# TGC Construction Review

**Issue Date:** Jul 4, 2014      **Location:** 500 Figueros St.  
**Prepared By:** Steven Evans      **Project Name:** TGC Headquarters  
**Project Number:** 14.016      **Project Type:** Office  
**Subject:** Punchlist

import(02).png

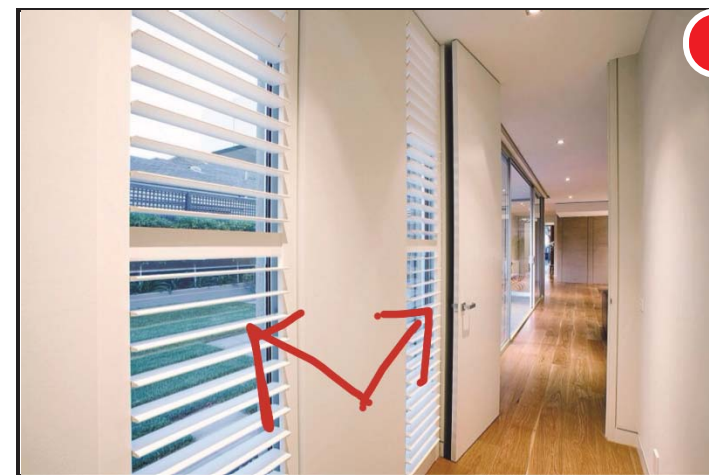
#	Dev / Code	Location	Scope	Item	Description	Image 1	Image 2	Status	Date Entered	Deadline Date	Age In Days	Cited By	Action By	Spec Section	Priority	Pin	Video	Audio
1	YES	Stair 2 Level 9 Landing	AA	DN	The handrail extension to not meet the required length. See sheet A7.01 for dimensions and A0.55 for Accessibility standards. Correct handrail extension as designed.	 import.png	 scratch.png	Open	Jun 4, 2014	Sep 4, 2014	52	SE	BH	102616.16	High	1014_TG H_Rev4.pdf	YES	NO
2		Conference Room 2-34	AA	CN	Repair tile to carpet transition.	 import(00).png		Open	Jul 4, 2014	Aug 4, 2014	22	JG	BH	096519	Med		NO	NO
3		Loading Dock Entry. Room 1-66	HA	CN	Replace Corner guard. Protect from construction related damage.	 import(01).png		Open	Jul 4, 2014	Aug 4, 2014	22	JG	BH	102613	Low	1014_TG H_Rev4.pdf	NO	YES
4	YES		AA	DN	Provide plumbing heat protective cover. See A0.51 for Accessibility standards.	 import(02).png		Open	Jul 4, 2014	Aug 4, 2014	22	SE	BH	055819	High		YES	NO

import(09).png

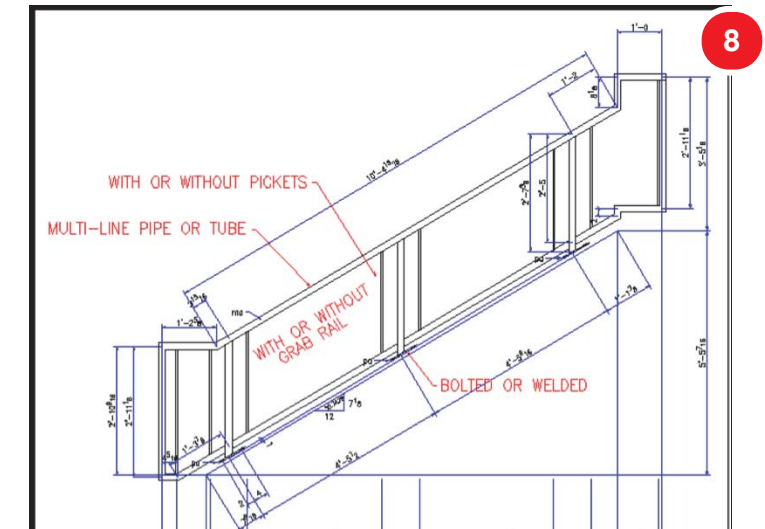
#	Dev / Code	Location	Scope	Item	Description	Image 1	Image 2	Status	Date Entered	Deadline Date	Age In Days	Cited By	Action By	Spec Section	Priority	Pin	Video	Audio
8	YES		ID	IR	Inspector requested stair stringer calculations. Architect to request calculations from Stair manuf.	 import(09).png		Open	Jun 4, 2014	Jul 4, 2014	52	BH	SE	096956	Med	1014_TG H_Rev4.pdf	YES	NO
9	YES	Penthouse Stair - Room 11-03	FP	CN	Provide 1 layer of 5/8" type X gyp underside stair throughout per Detail 6/A5.11.	 import(10).png	 scratch(00).png	Open	Jul 4, 2014	Aug 4, 2014	22	SE	BH	035116	High	1014_TG H_Rev4.pdf	NO	NO
